Memorandum

SUBJECT: PDC13-020. PLANNED DEVELOPMENT ZONING FROM R-1-8 SINGLE-FAMILY RESIDENTIAL TO A(PD) PLANNED DEVELOPMENT ZONING DISTRICT TO ALLOW THE DEVELOPMENT OF UP TO 13 SINGLE-FAMILY RESIDENCES AT THE SOUTHEAST CORNER OF PEARL

AVENUE AND ADAMO DRIVE (5000 PEARL AVENUE).

PD Rezoning for 5000 Pearl Avenue (PDC13-020)

February 21, 2014 Site Layout Plan

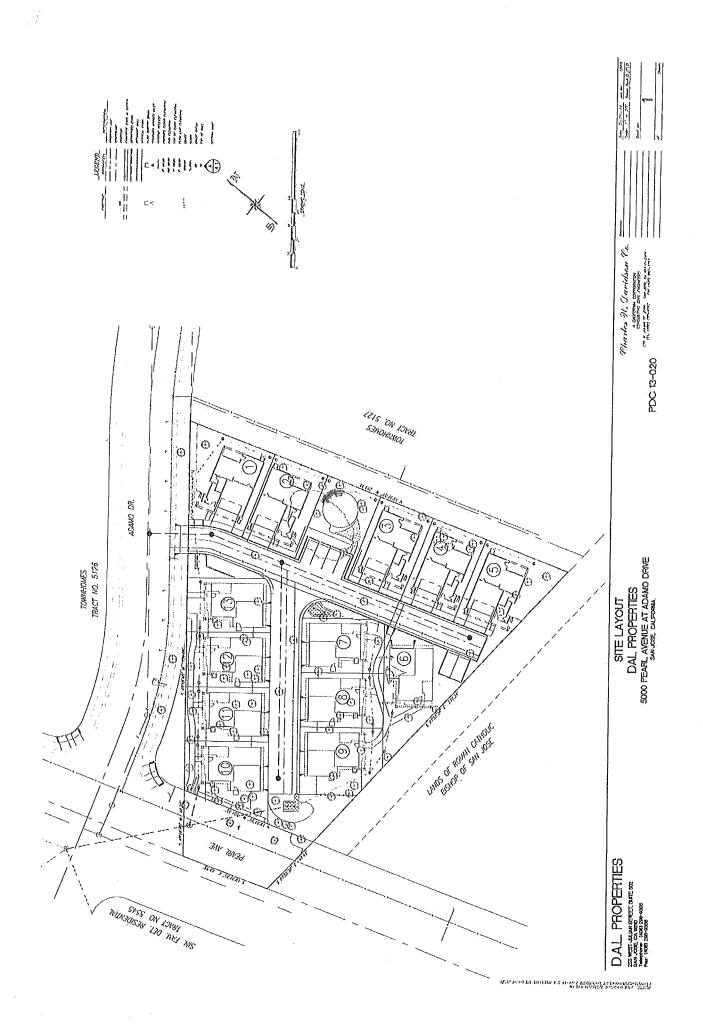
I have reviewed the attached Site Layout Plan prepared by the Charles Davidson Co. (dated February 21, 2014). While the plan does not include an accurate trunk location for tree #143, the dripline is shown. The plan proposes to construct parking stalls southwest of the tree and a play structure to the northeast. The Lot 2 building would be constructed within the trees dripline to the northwest. A drain line would be installed along the northeastern property line. The plans do not include details on grading, drainage and utilities other than the drain line and as such need further evaluation.

Without more specific information on the proximity of improvements and the nature and depth of excavation, I cannot say if the tree would tolerate the impacts associated with the plan as designed. In general, the improvements appear too close to adequately protect the tree.

- Have the bees removed from the tree.
- Have an aerial inspection performed to identify any structural defects present in the crown that could not be identified from the ground.
- Have the areas of decay tested to determine the amount of sound wood present.
- Based on the results of these investigations, pruning, cabling and additional testing may be recommended.
